UNITED STATES PATENT AND TRADEMARK OFFICE

APPLICATION NO.	FILING DATE	FIRST NAMED INVENTOR	ATTORNEY DOCKET NO.	CONFIRMATION NO.
10/768,373	01/30/2004	Thomas Hezel	BHR-100-A	6529

Office Action Summary

DETAILED ACTION

FIG - 4

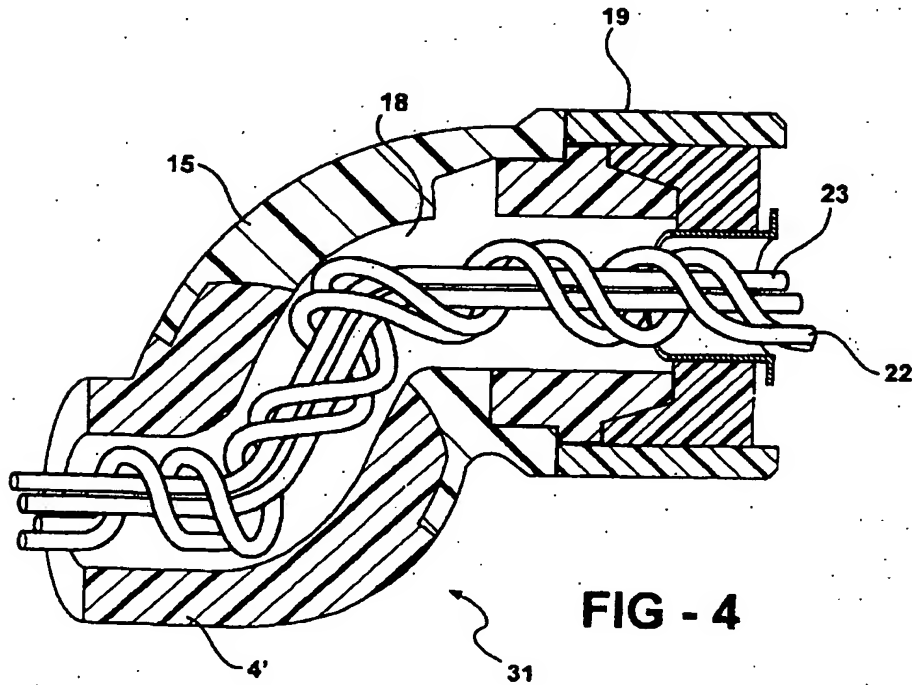
6. The drawings are objected to because In Fig 2a "14" should designate a bellow, "9" should designate a line; in Fig 2b "3" should designate a wrist axis, "14" should designate a bellow; in Fig 4 "18" should designate a pleated bellow; in Fig 3a "12" should designate a mounting plate; in Fig 3b "12" should designate a mounting plate, "17" should designate a single hole. Corrected drawing sheets in compliance with 37 CFR 1.121(d) are required in reply to the Office action to avoid abandonment of the application. Any amended replacement drawing sheet should include all of the figures appearing on the immediate prior version of the sheet, even if only one figure is being amended. The figure or figure number of an amended drawing should not be labeled as "amended." If a drawing figure is to be canceled, the appropriate figure must be removed from the replacement sheet, and where necessary, the remaining figures must be renumbered and appropriate changes made to the brief description of the several views of the drawings for consistency. Additional replacement sheets may be necessary to show the renumbering of the remaining figures. Each drawing sheet submitted after the filing date of an application must be labeled in the top margin as either "Replacement Sheet" or "New Sheet" pursuant to 37 CFR 1.121(d). If the changes are not accepted by the examiner, the applicant will be notified and informed of any required corrective action in the next Office action. The objection to the drawings will not be held in abeyance.
